Access Compliance Report

Public Rights-of-Way

Intersection ID: 11521	Main Street: W_11TH_ST	Cross Street: N_CHURCH_ST	Location:	N
ADA ID: F4E2D18AD6D5	Ramp Type: PerpDiag	Initial Pass/Fail: Fail	Overall Compliance: No	Severity Score: 10

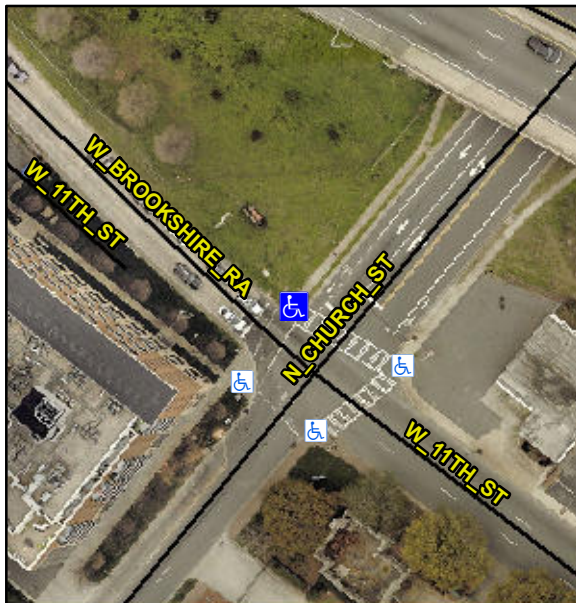
Not Found, R304.5.1, R304.5.3

Compliance	Description	Data	Compliance	Description	Data
N/A	Ramp Length (in)	33.0	Yes	Ramp Slope (%)	6.6
No	Ramp Width (in)	36.0	No	Ramp XSlope (%)	2.3
N/A	Flare Type LT	N/A	N/A	Flare Type RT	N/A
N/A	Flare Slope LT (%)	N/A	N/A	Flare Slope RT (%)	N/A
N/A	Flare Traversable LT?	N/A	N/A	Flare Traversable RT?	N/A
N/A	Landing Length (in)	N/A	N/A	DWS Provided?	N/A
N/A	Landing Width (in)	N/A	N/A	DWS Contrast?	N/A
N/A	Landing Slope (%)	N/A	N/A	DWS Length (in)	N/A
N/A	Landing X Slope (%)	N/A	N/A	DWS Full Width?	N/A
N/A	Landing Curb? (Y/N)	N/A	N/A	DWS Offset (in)	N/A
N/A	Shared Landing?	N/A			
N/A	Gutter Ponding?	N/A	N/A	Gutter Slope (%)	N/A
N/A	Gutter Lip Ht (in)	N/A	N/A	Gutter X Slope (%)	N/A
N/A	Painted X Walk1?	Yes	N/A	Painted X Walk2?	Yes
	X Walk 1 Direction	To SW		X Walk 2 Direction	To SE
N/A	X Walk 1 Width (in)	134.0	N/A	X Walk 2 Width (in)	120.0
	X Walk 1 Slope (%)	3.7		X Walk 2 Slope (%)	4.0
	X Walk 1 X Slope (%)	4.3		X Walk 2 X Slope (%)	4.1

N/A	Ramp inside XWalk1?	Yes	N/A	Ramp inside XWalk2?	Yes
	Road Slope (%)	0.2	N/A	Clear Space?	N/A
	Road X Slope (%)	10.3	N/A	Clear Space to XWalk (in)	N/A
N/A	Any Obstructions?	N/A	N/A	Storm Grate/Utility Hazard?	N/A
	Obstruction Type			Storm Grate/Utility Type	
		N/A			N/A
		Yes		Surface Condition? (G/P)	Good

Remove & Replace Curb Ramp With Two New Directional Ramps or Equivalent.
